Memorandum

SUBJECT: Review of DIC Project No. Z2025000111
8445 Galloway, LLC
DTPW Project No. OSP169

The subject property located at 8445 SW 94th St. Miami, FL 33156, in unincorporated Miami-Dade County, Florida (the “Property”).

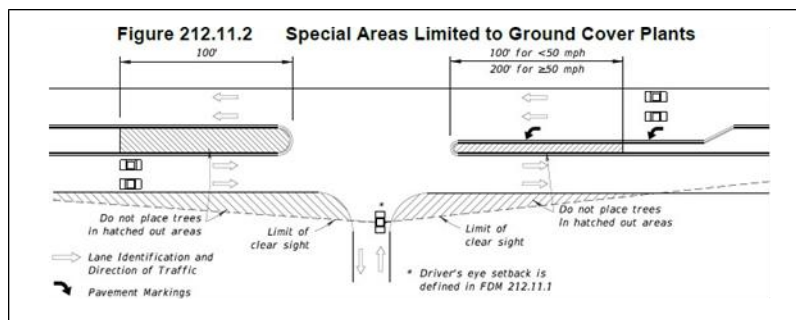
1. Exit driveways must comply with clear sight visibility requirements for both pedestrians and vehicular traffic. Provide clear sight visibility triangles on the site and landscape plans to demonstrate

compliance with these requirements. Please ensure to clearly illustrate both (pedestrian and vehicular) sight triangles following the MDC Traffic Operations Manual and FDOT Standards. Note that according to the latest FDOT FDM manual Section 212.11.6, trees may not be placed within the hatched-out areas of the sight triangles, as shown in the figure below.
